1 REDLINE REVISION 6/18/08
TEDD APPROVAL 6-19-08

MD 64 AND PANGBORN BLVD

HAGERSTOWN, MARYLAND

GENERAL INFORMATION SHEET

WIRING DIAGRAM

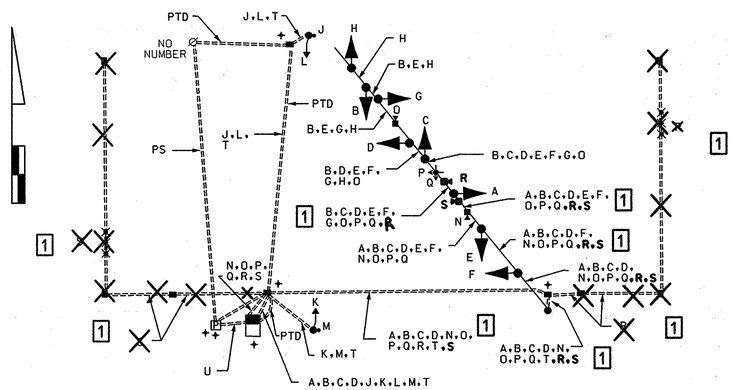
1 N O R S } CONTROL CABLE (CAMERA TO CONTROLLER) UP TO 500'

~~R S } NON-INVASIVE MICROLOOP LEAD-IN CABLE~~ 1
